TO: Beck & Bellucci, Inc. PO Box 429 Franklin, NH 03235	DATE: 11/26/14 ECS JOB NO. 1433	ATTENTION: Chris Schroeder RE: Waterbury IM 089-2(43)
---	--	--

<u>Original</u>	<u>Submitted</u>	<u>DESCRIPTION</u>
	1	11-26-14	Cross Engineering SB Ramp Mast Arm Foundation Design

EAST COAST SIGNALS
Traffic Signal Foundation Design
Waterbury, VT

Traffic Pole Foundation Design
Intersection of Route 100 and Exit 10

EX-2

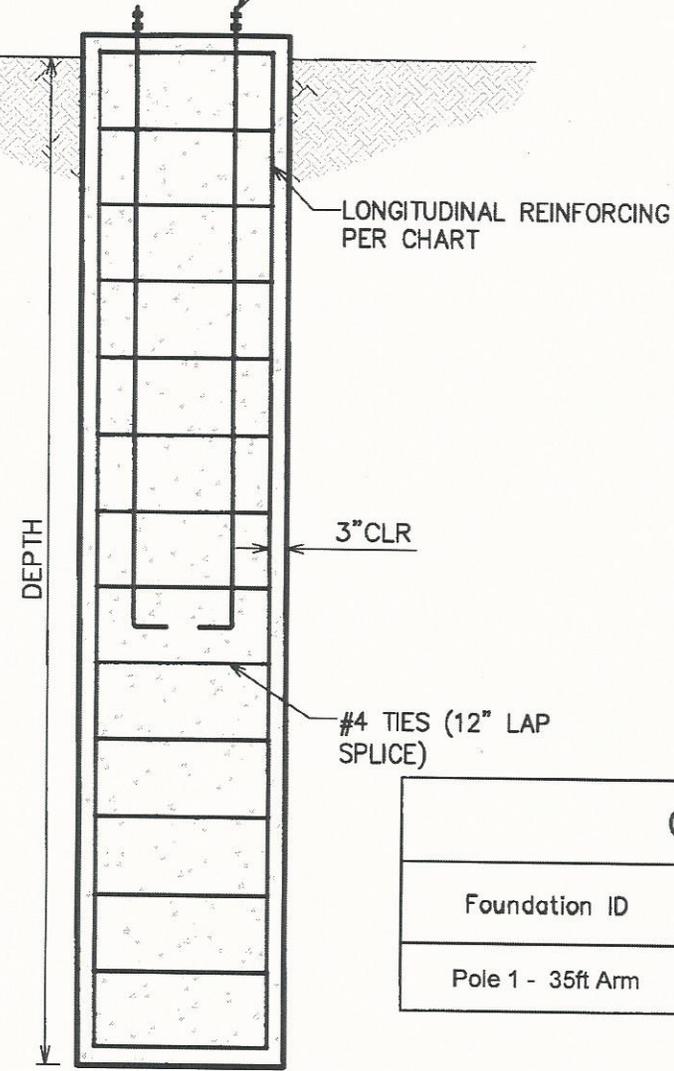
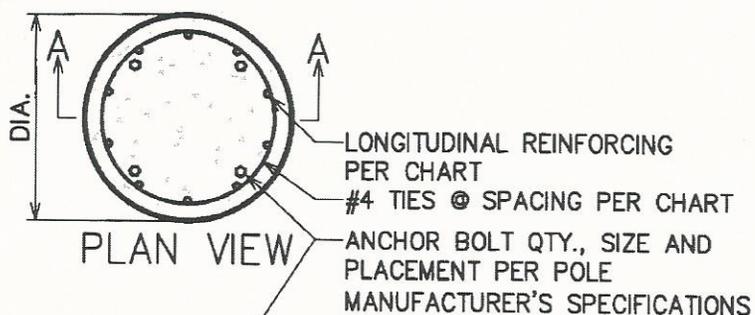
Does this apply if permanent casing is used? is it reduced? (I do understand the design has plenty of tip resistance regardless)

Any reduction required here if permanent casing is used?

Comment addressed in separate submittal, no change necessary

Comment addressed in separate submittal, no change necessary
